LIC-13-0060
May 21, 2013

SUBJECT: Remaining Responses to Second Request for Additional Information Re: License Amendment Request to Adopt NFPA 805 at Fort Calhoun Station (TAC No. ME7244)

**Omaha Public Power District's (OPPD's)
Remaining Responses to Second Request for Additional Information
License Amendment Request to Adopt National Fire Protection Association Standard 805
Performance-Based Standard for Fire Protection for Light Water Reactor Generating Plants
Fort Calhoun Station (FCS), Unit 1 (TAC No. ME7244)**

Sketches of Conceptual Proposed Design Option(s)
as Described for REC-112
in Attachment S of the Transition LAR (LIC-11-0099)

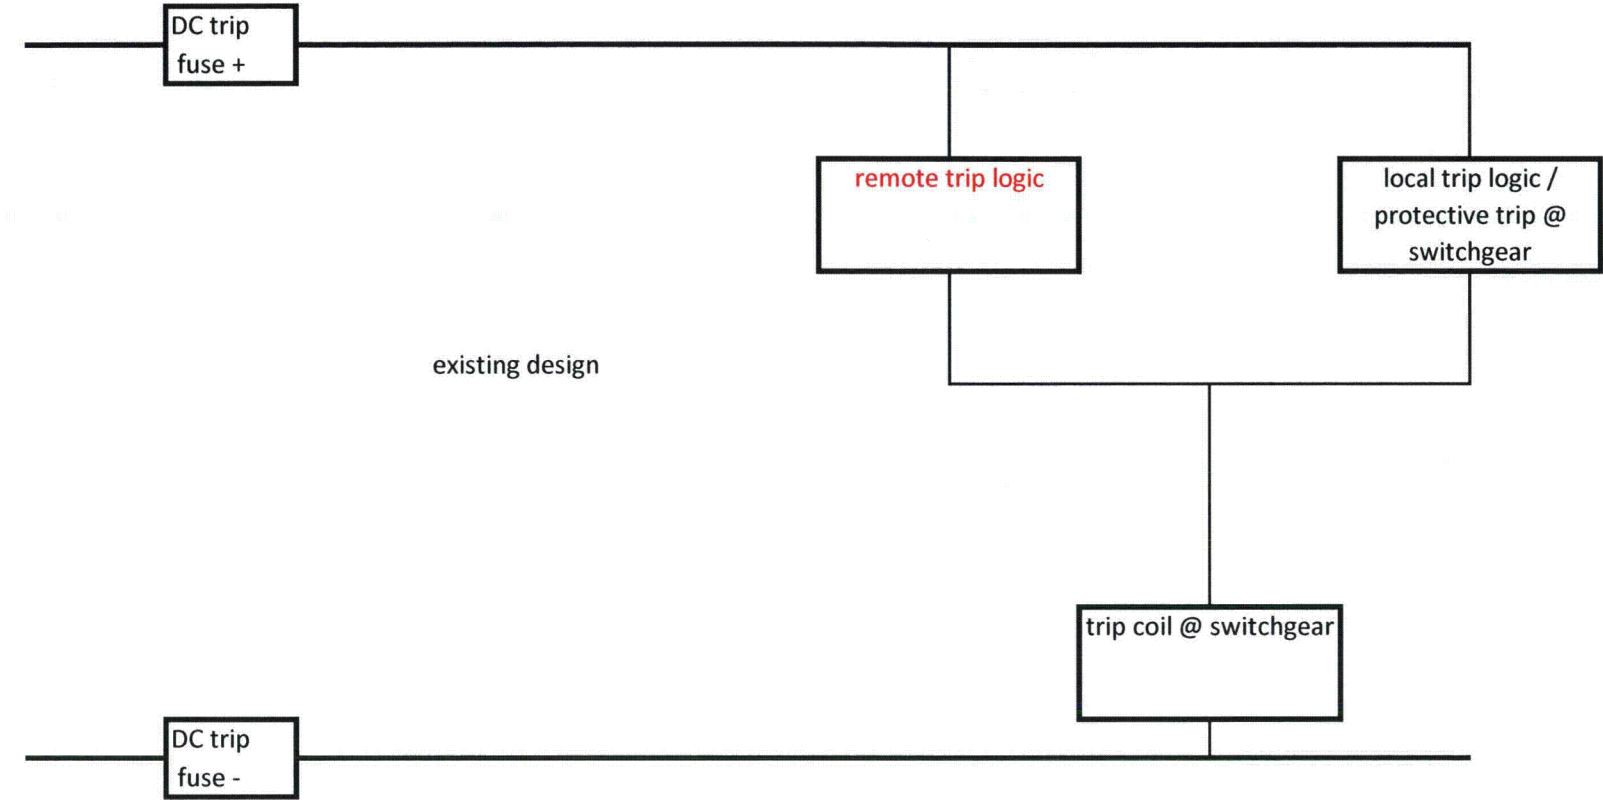
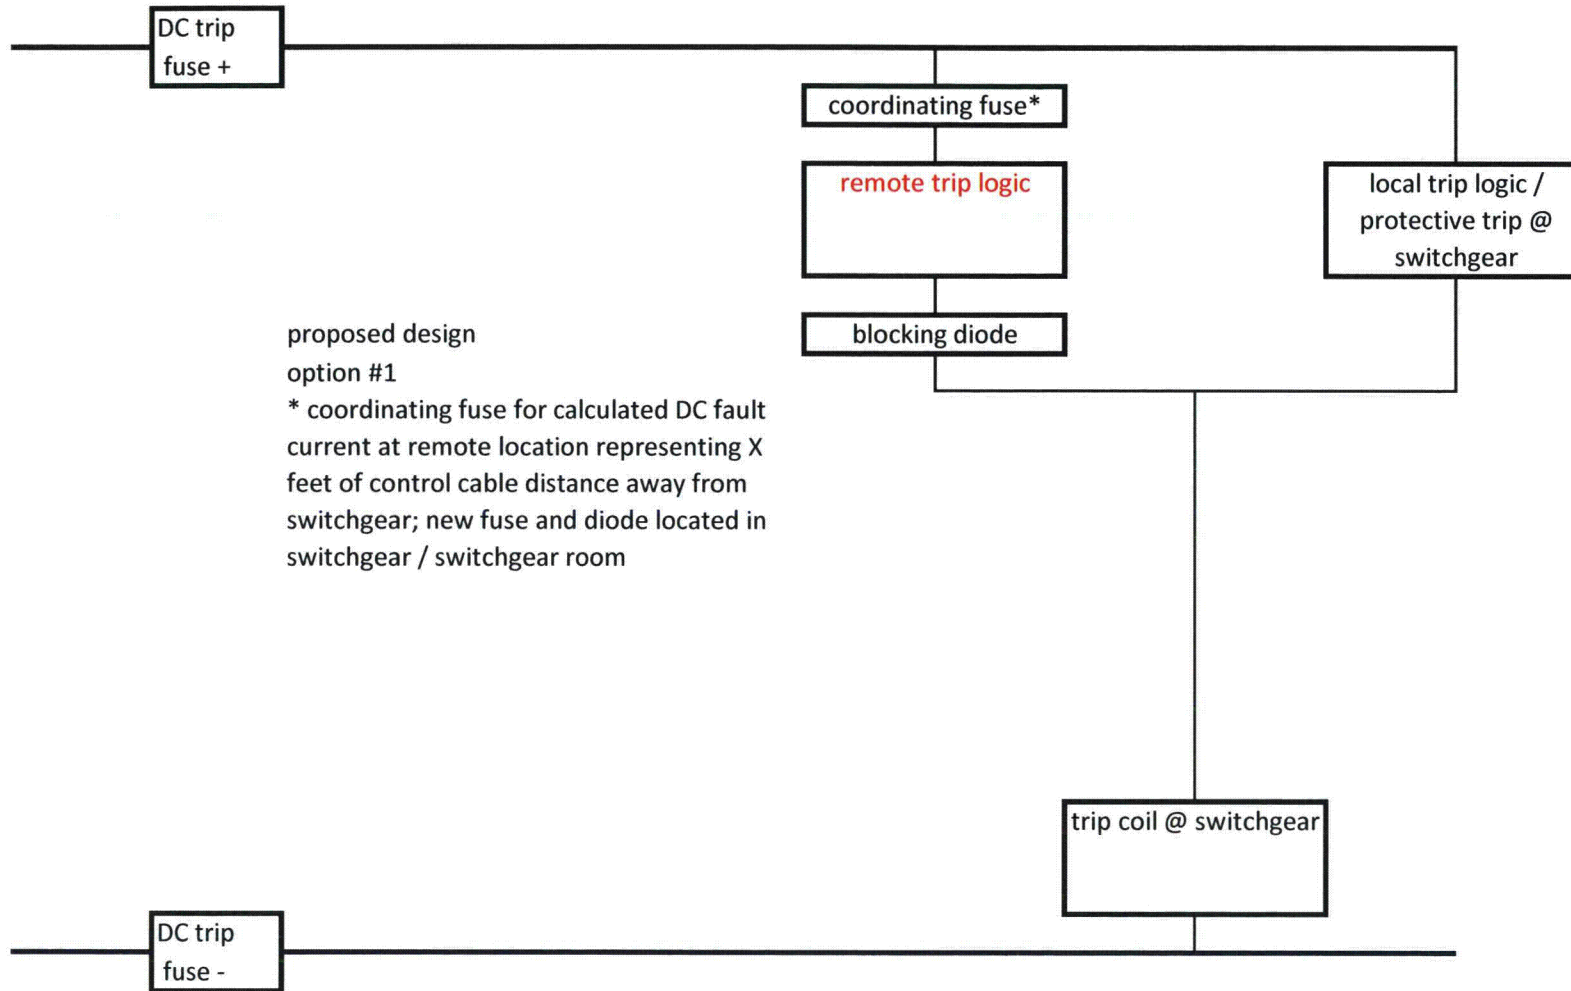
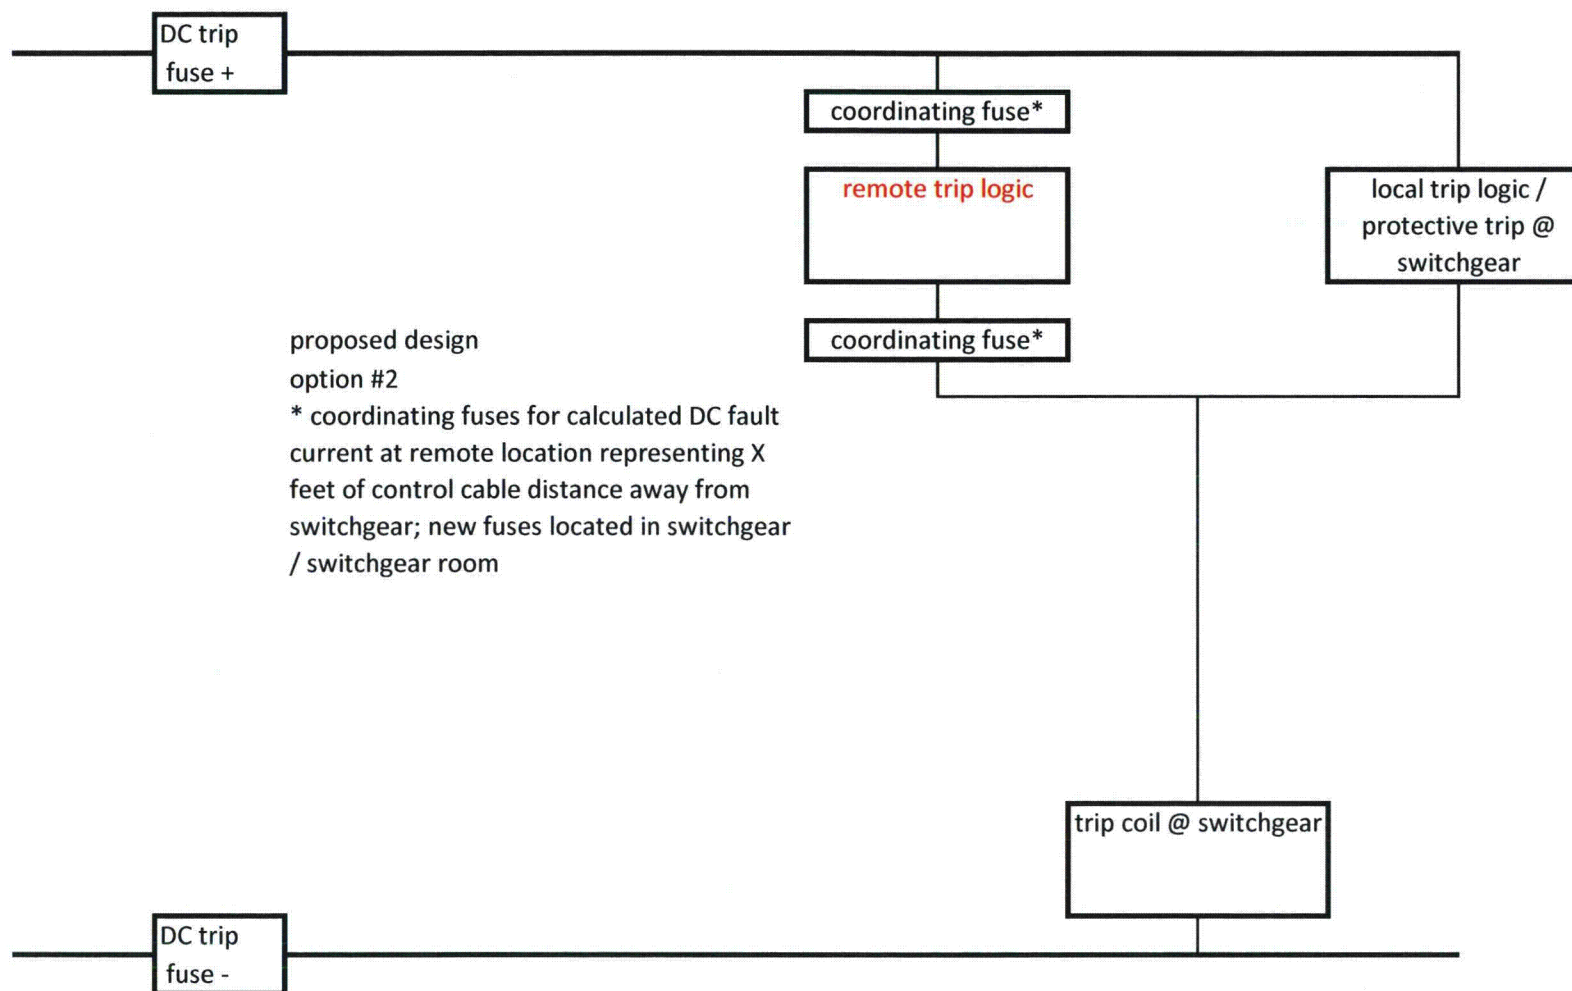
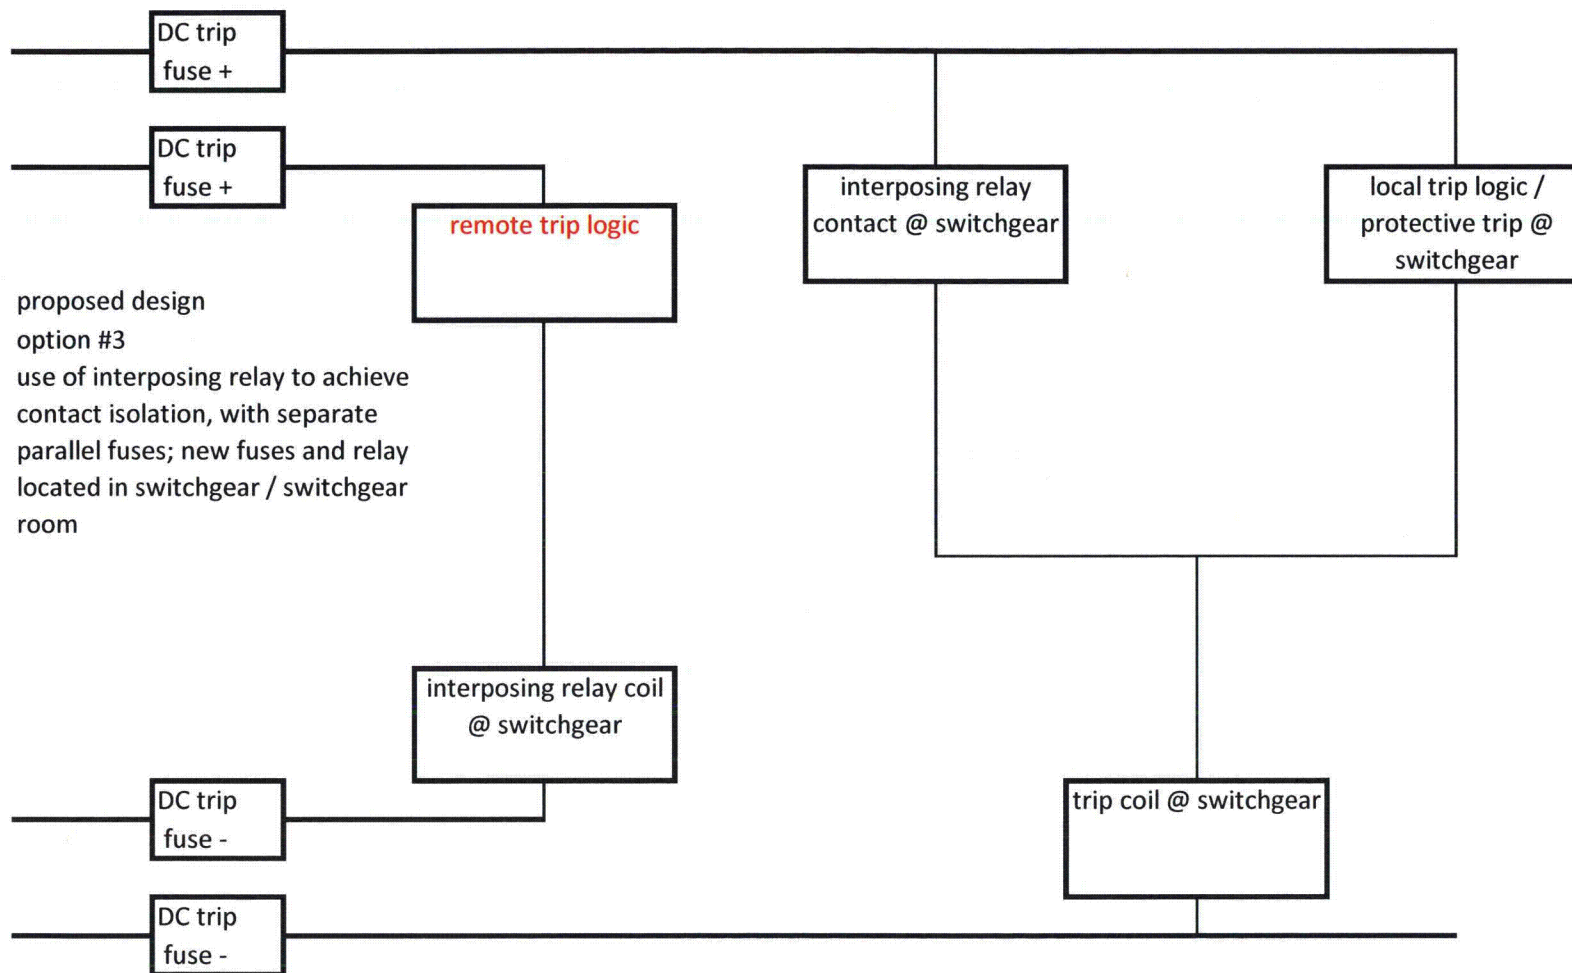
LAR Attachment S for the proposed plant modification REC-112 states “the purpose of these modifications is to ensure that the breakers will remain functional to trip on demand for automatic load shed, overcurrent, and manual control from the main control room. These modifications generally involve wiring changes within the switchgear cubicles, installation of additional coordinated DC control power fuses within the switchgear cubicles, and/or installation of interposing relays within the switchgear cubicles.” The applicable breakers are: 1A1-0 (FP-1A); 1A1-1 (FW-5A); 1A1-2 (FW-4A); 1A1-3 (FW-2A); 1A1-4 (CW-1A); 1A2-6 (CW-1B); 1A2-7 (FW-2B); 1A2-8 (FW-4B); 1A2-9 (FW-5B); 1A4-3 (CW-1C); 1A4-4 (FW-5C); 1A4-5 (FW-4C); and 1A4-6 (FW-2C).

The LAR for REC-112 also states “this proposed modification addresses issues associated with loss of overcurrent trip capability for load breakers (trip and lockout of credited switchgear and secondary fires). The proposed modification will maintain breaker manual trip capability from the main control room, protective trip, automatic load shed trip and accident signal trip for fire areas 31, 46, and 47.”

Please provide a more detailed description of the modifications for various breakers (typical(s) for various breakers), including fuse coordination curves with the upstream protective devices.

The Enclosure, Attachment 2 provides sketches of the conceptual proposed design option(s) to achieve the objective of the associated plant modification for NFPA 805 as described for REC-112 in Attachment S of the transition LAR (LIC-11-0099). As discussed with the NRC during the March 11, 2013, teleconference with the NRC Project Manager and technical reviewers, the specific design details will be developed during NFPA 805 implementation.

Pyrocrete® Encased Conduit Locations for Tray Section 34S-1
Drawing 11405-E-67, Sheet 78

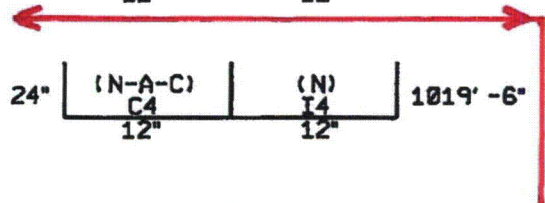
- c. During the site audit walk down of fire area 36A (east switchgear room), the NRC staff noticed the horizontal Pyrocrete® assembly intersected with a non-protected cable tray (approximately mid-room). The Pyrocrete® configuration at this intersection did not appear to match the normal Pyrocrete® assembly, nor the description contained in Attachment L, Approval #7, page L-14. Please clarify whether the configuration at this intersection is acceptable and meets the analyzed configuration. Please provide the basis for the conclusion and any reference to the engineering analysis and testing. Identify the non-protected cables intersecting this Pyrocrete® assembly (e.g. division, equipment/system).

The cable tray in the east switchgear room is completely enclosed with 2 inches of Pyrocrete® on metal lath between the adjacent intersecting exposed cable trays. This configuration is consistent with other Pyrocrete® enclosures at FCS. As identified in response to Fire Protection Engineering RAI 18.01a, the results of the time-temperature testing data documented in Attachment B to letter LIC-80-0062 that a 2-inch thickness of Pyrocrete® did not reach 250°F above ambient for 195 minutes. Since this configuration was employed prior to the issuance of Generic Letter 86-10 Supplement 1, and was tested against the end point temperature requirements similar to the acceptance criteria of NFPA 251 that are identified in Generic Letter 86-10 Supplement 1, the Attachment L request is no longer required, as identified in the original response to Fire Protection Engineering RAI 18.

The tray section identification for the cables is 34S-1. There are four trays in the 34S-1 stack. The Pyrocrete® enclosed conduits pass between the lowest tray at elevation 1019'-6" and the next highest tray at elevation 1020'-6". (Reference drawings 11405-E-73, Sheet 1 and 11405-E-67, Sheet 78) Attachment 3 provides drawing 11405-E-67, Sheet 78, delineating the Pyrocrete encased conduits location relative to the tray sections. In addition, Attachment 3 includes the FCS Cable Route Report from the FCS Automated Cable Tracking System (FACTS) cable routing database for the cables identified in tray section 34S-1 intersecting this Pyrocrete® assembly.
